VIRGINIA ELECTRIC AND POWER COMPANY  
RICHMOND, VIRGINIA 23261

AMENDMENT TO OPERATING LICENSES  
SURRY POWER STATION UNIT NOS. 1 AND 2  
PROPOSED TECHNICAL SPECIFICATION CHANGE

EVALUATION OF PROPOSED TECHNICAL SPECIFICATION CHANGES  
UNIT NO. 1

PROPOSED TECHNICAL SPECIFICATION CHANGES

MAXIMUM ALLOWABLE AIR PARTIAL PRESSURESURRY POWER STATION - UNIT NO. 1

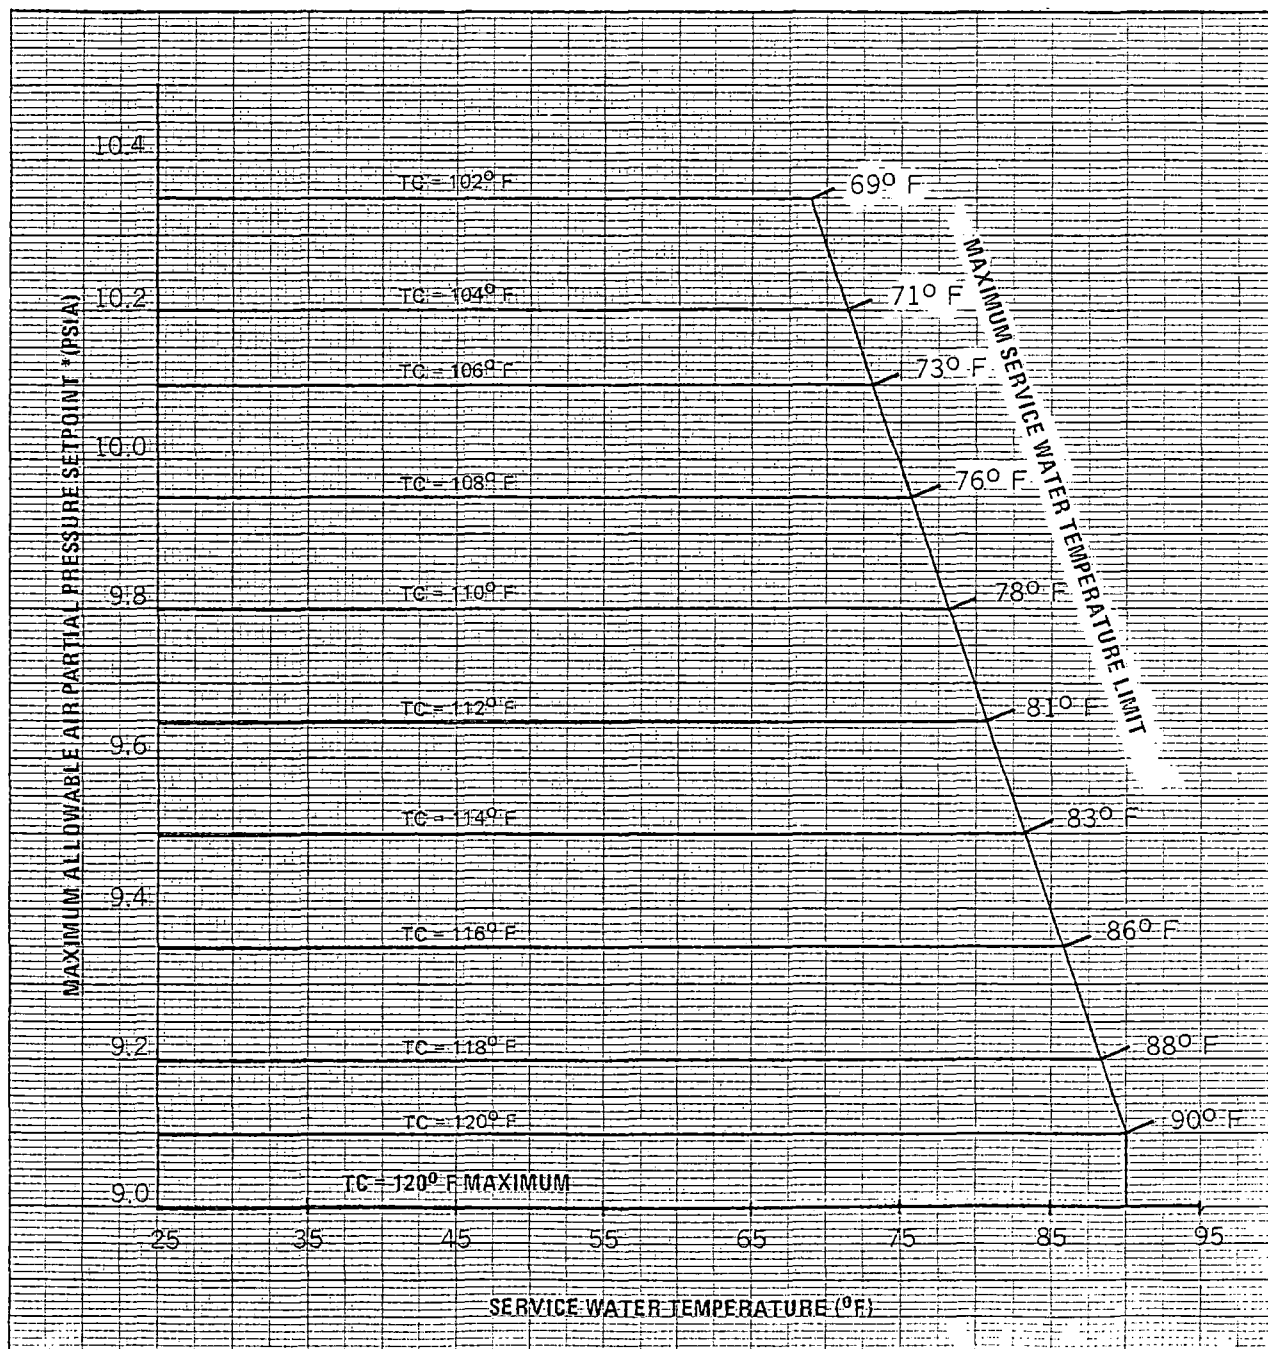
10. Section 3.8 - Changes have been made in order to reflect the results of the reanalysis of the Containment Spray and Recirculation Spray subsystems in regards to post-LOCA containment depressurization. Previously, this depressurization time was based on pressure transients as a result of a reactor hot leg break. In order to increase conservatism and bound more restrictive LOCA depressurization transients, reanalyses were performed based on cold leg pump suction doubles ended rupture with minimum engineered safety features. As a result of reanalyses, it was determined that pressure transients would reach a higher peak pressure and at a later time than that of the original analysis, thus increasing the depressurization time to 46.6 minutes.

The maximum allowable setpoint for the containment air partial pressure is bounded by both containment average temperature and service water temperature. The containment average temperature and the corresponding containment air partial pressure are based on LOCA peak calculated pressure criteria performed as part of the Containment Integrity Analysis. The maximum service water temperature limits for corresponding containment average temperature and air partial pressure are based on LOCA atmospheric peak pressure criteria. These analyses and the NPSH re-analysis have confirmed that sub-atmospheric conditions are reached and maintained in less than one hour following LOCA. It has also been confirmed through these analyses that the containment peak pressure limit of 45 psig is not exceeded at any time throughout the LOCA.

The maximum allowable set point for the containment air partial pressure is presented in Figure 3.8.1-1 for service water temperatures from 25 to 90°F. The allowable set point varies as shown in Figure 3.8.1-1 for a given containment average temperature. The RWST water shall have a maximum temperature of 45°F.

The horizontal limit lines in Figure 3.8.1-1 are based on LOCA peak calculated pressure criteria, and the sloped line is based on LOCA subatmospheric peak pressure criteria.

From Figure 3.8.1-1, if the containment average temperature is 112°F and the service water temperature is less than or equal to 81°F, the air partial pressure set point value shall be less than or equal to 9.65 psia. If the average containment temperature is 116°F and the service water temperature is less than or equal to 86°F, the air partial pressure set point value shall be less than or equal to 9.35 psia. These horizontal

MAXIMUM ALLOWABLE AIR PARTIAL PRESSURESURRY POWER STATION - UNIT NO. 2

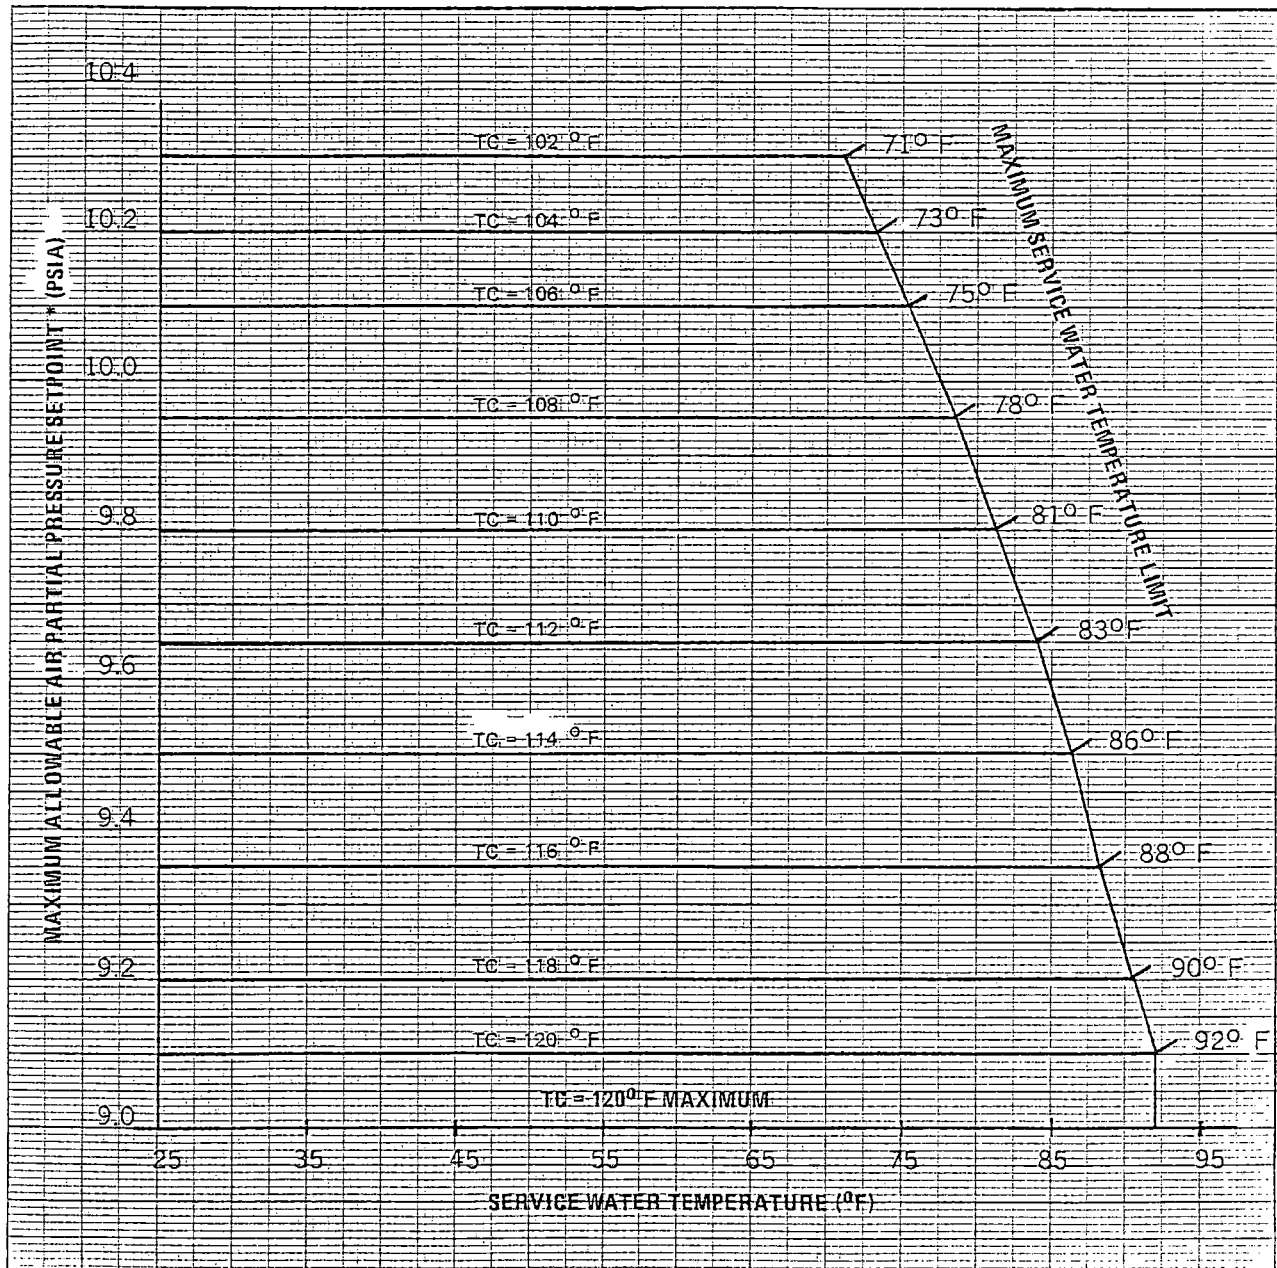
9. Section 3.8 - Changes have been made in order to reflect the results of the reanalysis of the Containment Spray and Recirculation Spray subsystems in regards to post LOCA containment depressurization. Previously, this depressurization time was based on pressure transients as a result of a reactor hot leg break. In order to increase conservatism and bound more restrictive LOCA depressurization transients, a reanalysis was performed based on cold leg pump suction double ended rupture with minimum engineered safety features. As a result of this reanalysis, it was determined that pressure transients would reach a peak pressure at a later time than that of the previous analysis, thus increasing the depressurization time to 45.3 minutes.

The maximum allowable set point for the containment air partial pressure is presented in Figure 3.8.2-1 for service water temperature from 25 to 90°F. The allowable set point varies as shown in Figure 3.8.2-1 for a given containment average temperature. The RWST water shall have a maximum temperature of 45°F.

The horizontal limit lines in Figure 3.8.2-1 are based on LOCA peak calculated pressure criteria, and the sloped line is based on LOCA subatmospheric peak pressure criteria.

From Figure 3.8.2-1, if the containment average temperature is 112°F and the service water temperature is less than or equal to 83°F, the air partial pressure set point value shall be less than or equal to 9.65 psia. If the average containment temperature is 116°F and the service water temperature is less than or equal to 88°F, the air partial pressure set point value shall be less than or equal to 9.35 psia. These horizontal limit lines are a result of the higher allowable initial containment average temperatures and the analysis of the pump suction break.
